SCI-823-0.00
PID Nos. 19415, 77366, 79977

Value Engineering Study Report
Draft Stage 2 Design Phase

re: SCI-823-0.00, PID Nos. 19415, 77366 and 79977, Portsmouth Bypass
Harrison, Jefferson, Madison and Porter Townships, Scioto County
Value Engineering Study Report

Alternative 12
Sheet 2 of 4

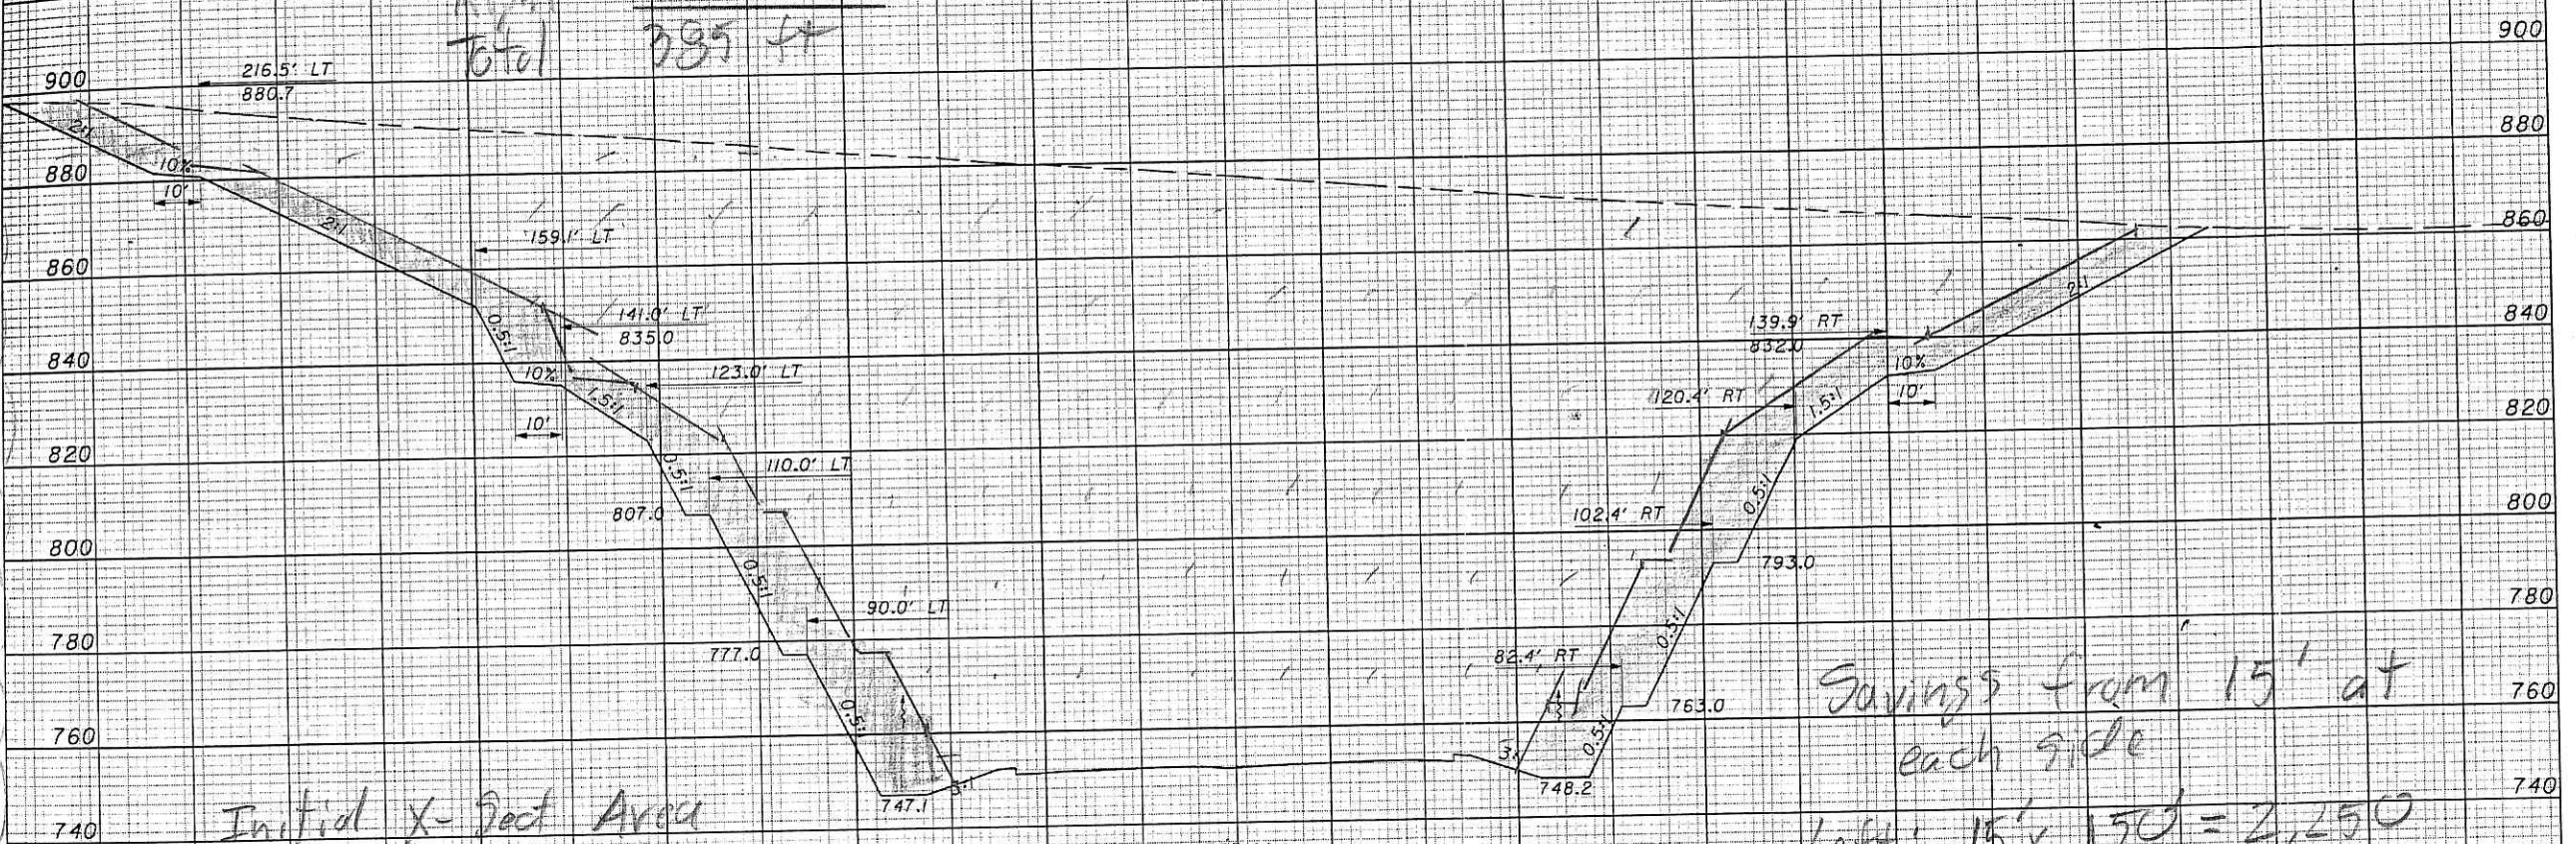
Initial x-sect area of cut = $33,200 \text{ ft}^2$
 (see drawing, by counting sq)

Savings in cut x-sect area = $3,900 \text{ ft}^2$
 (see drawing for calc)

Cost of rockfall mesh = \$4.00/sf based on
 3 projects in Colorado (Wolf Cr Pass, Hwy 6
 rockslide repair, Hwy 50/Blue Cr Canyon)
 Area of rockfall mesh from drawing = 385 ft
 Assuming 1 ft long section = 385 ft²
 Cost = (385 ft²)(\$4.00/sf) = \$1,540

SCALE
1" = 40'

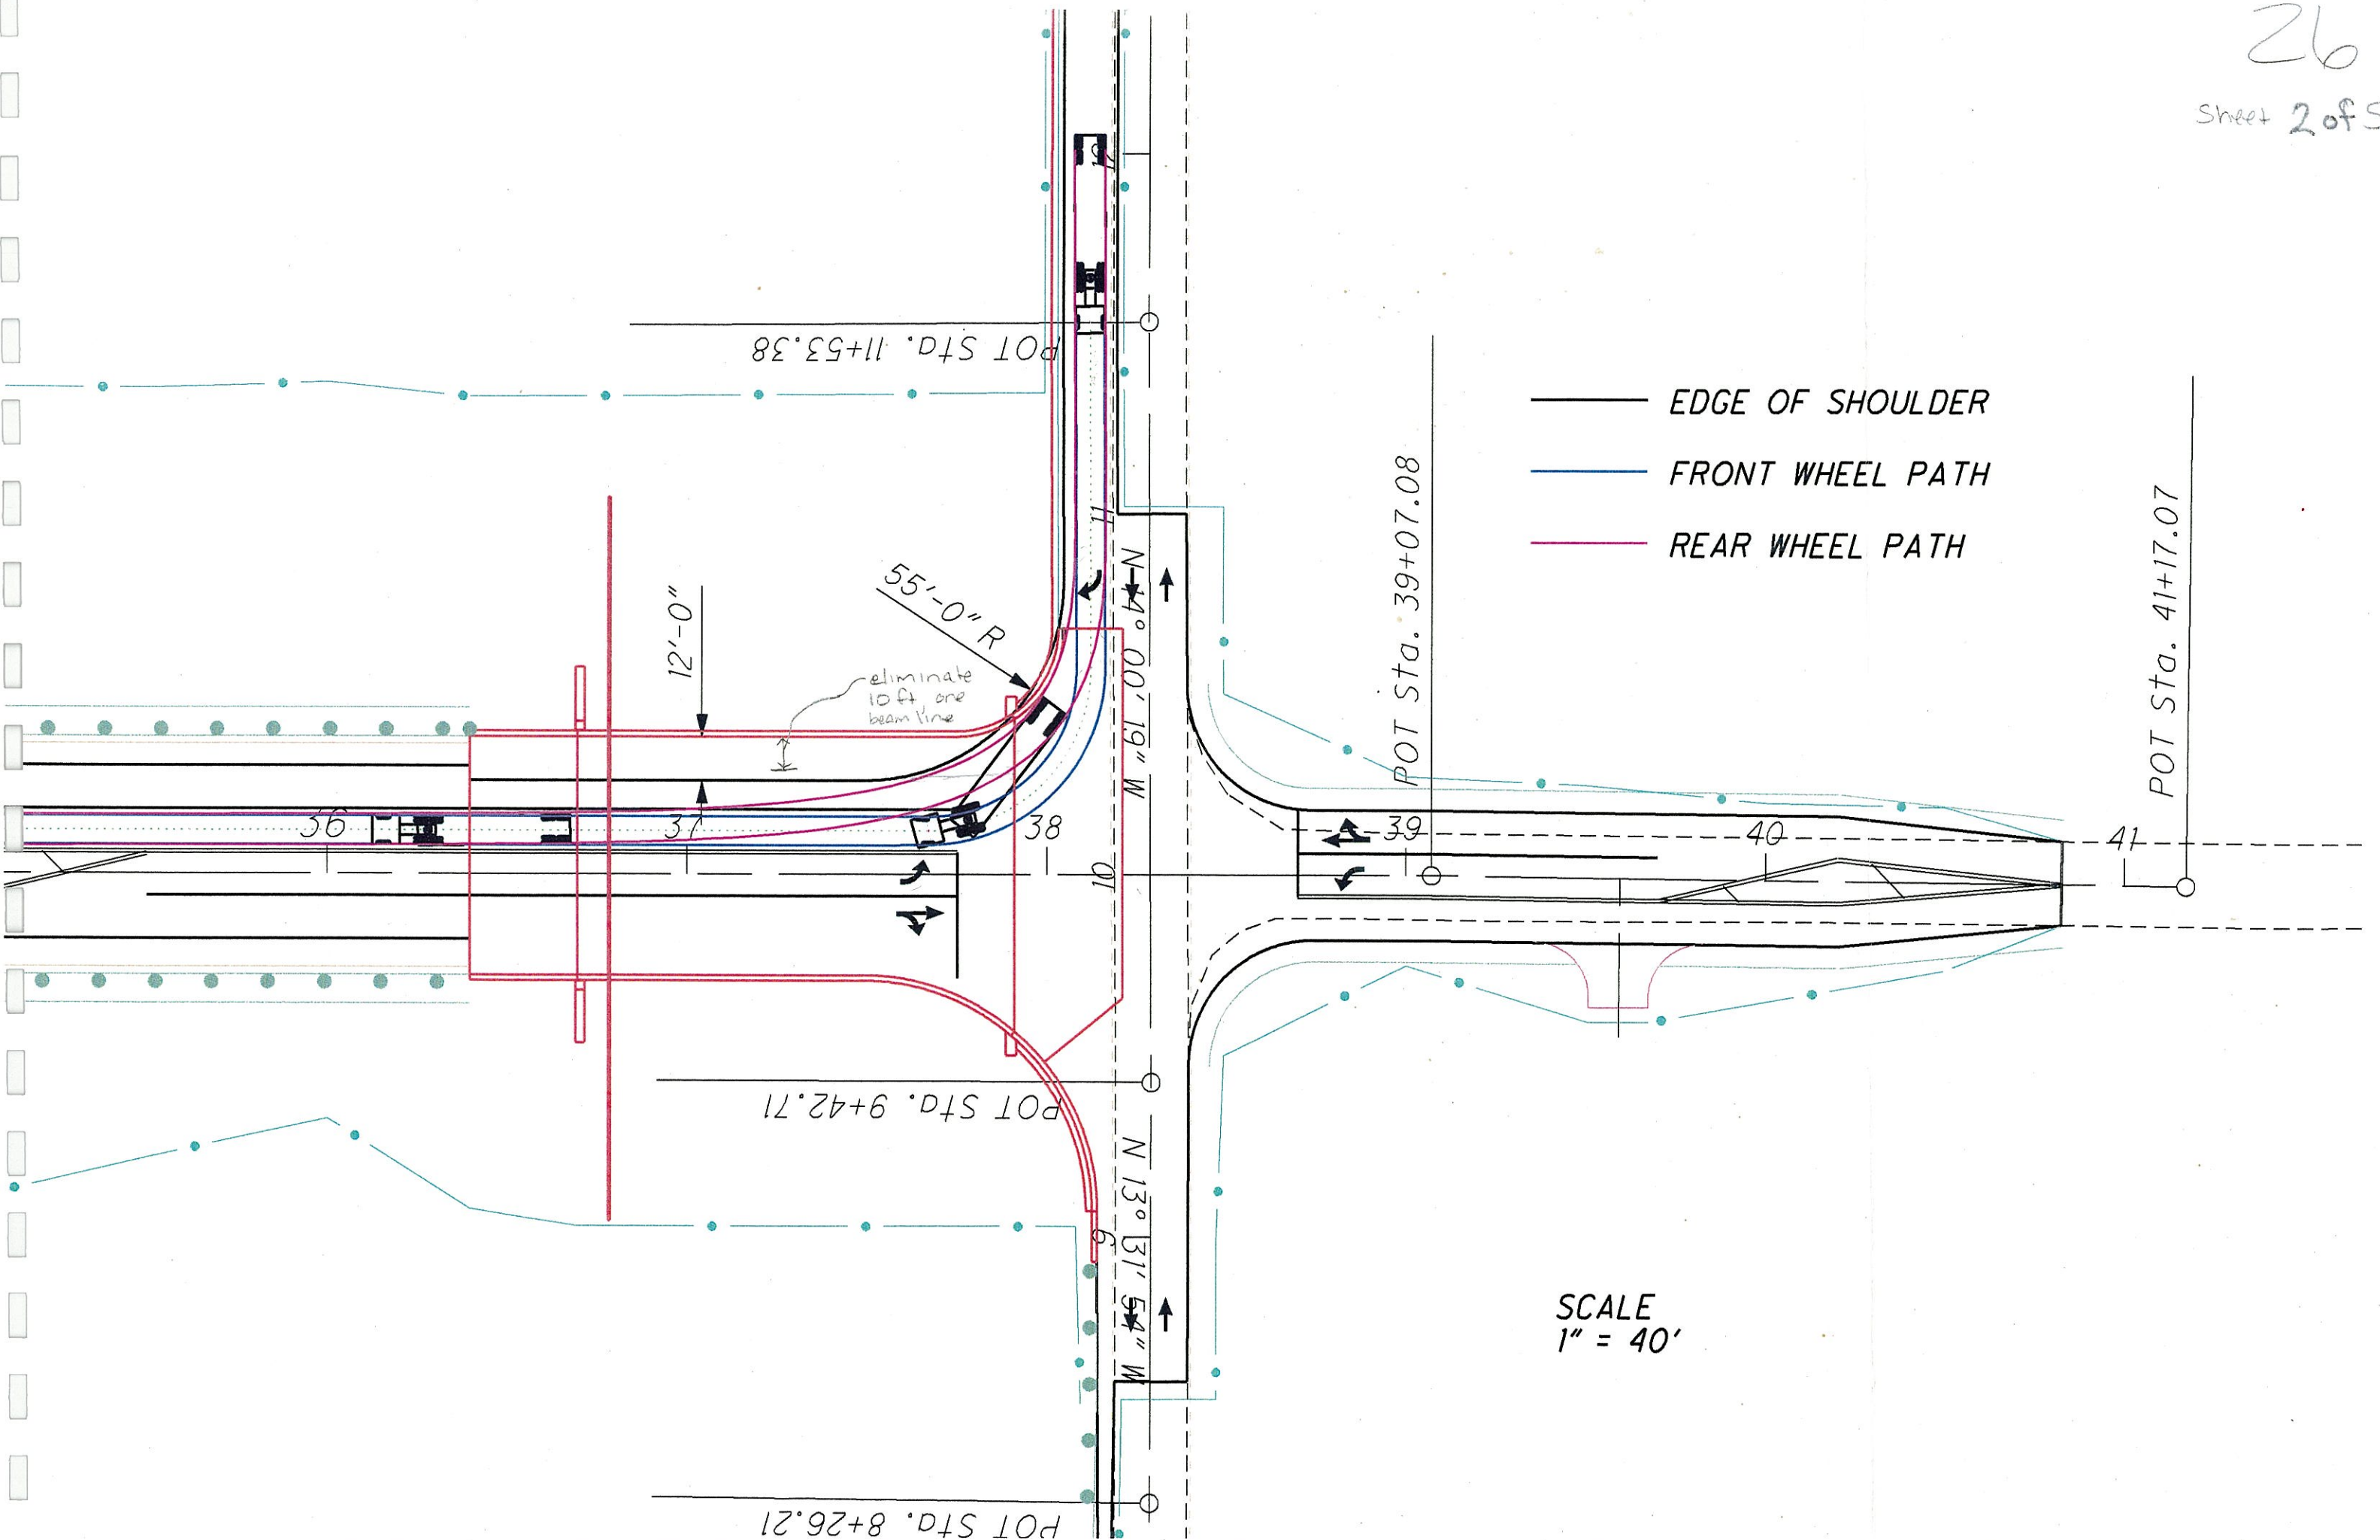
- Checked need for right most lane, which becomes
 exclusive right-turn lane onto Ramp A
- Ran autoturn for WB-SB turning right + left from SR335
 see attached run. Add'l 12 ft not needed for turning if shoulder can be
 used for rear wheel track. Will need to increase intersection
 radius from 30 ft to 55 ft, and rec. increasing shldr to 12 ft.
 Designer needs to verify final widths.

SHEET NO.: 2 of 7

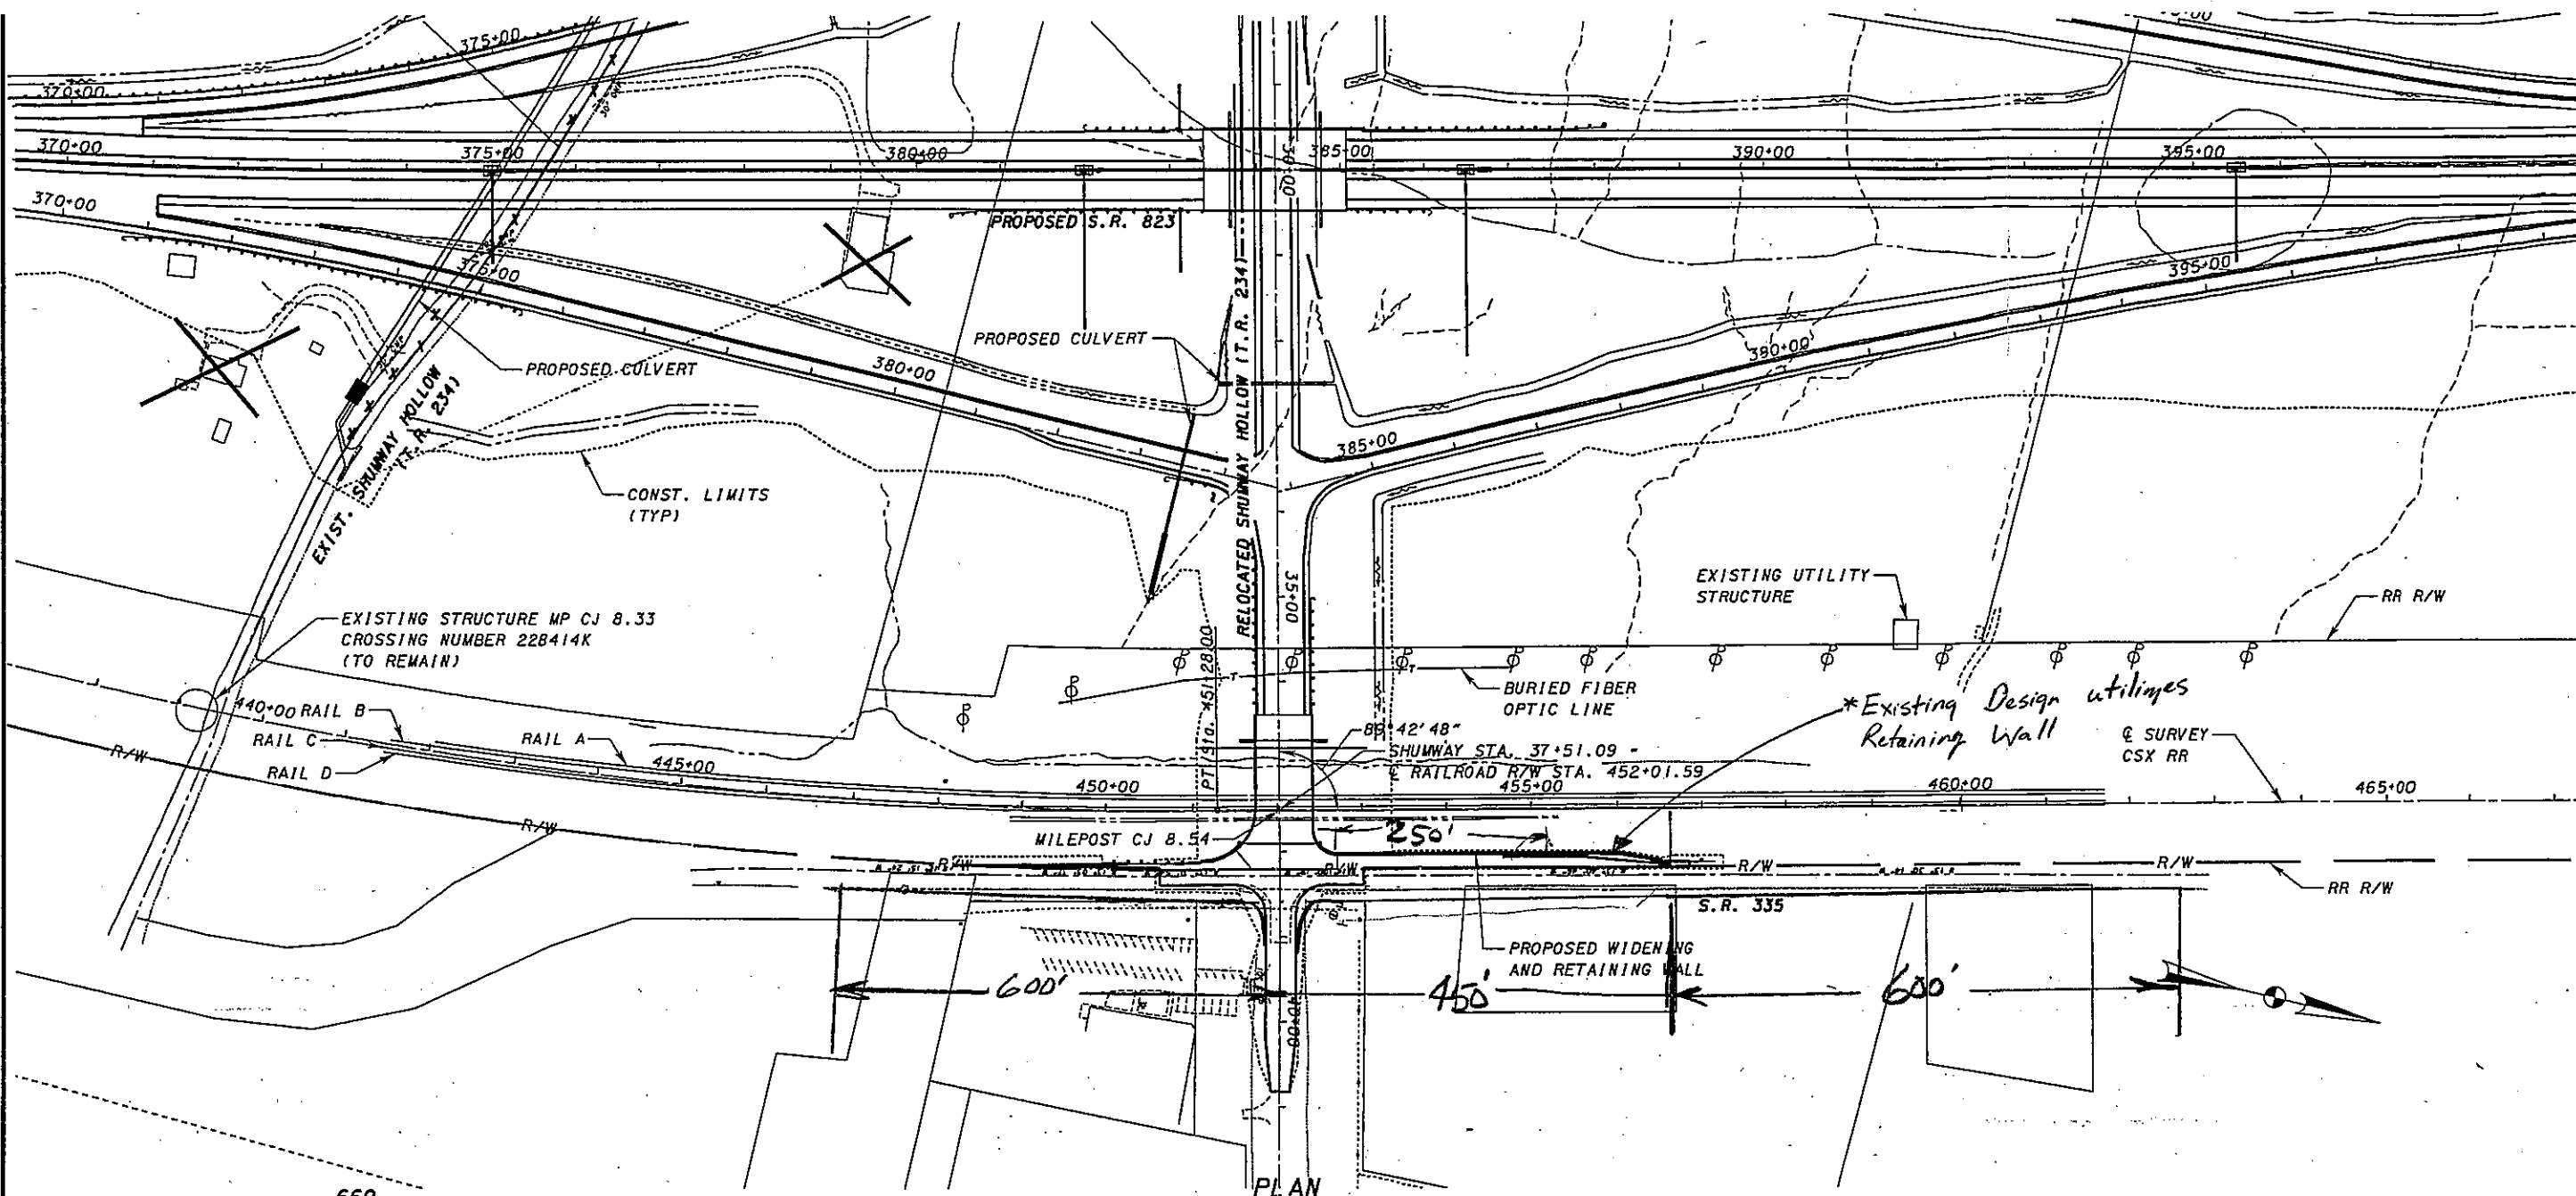
- ① Utilize current southbound lane as right turn lane onto Relocated Shumway Hollow Rd.
- ② Utilize current northbound lane as new (relocated) southbound lane for S.R. 335.
- ③ Construct short (<450') length of pavement for new lane for northbound S.R. 335. Assume 600' taper for lane shifts.
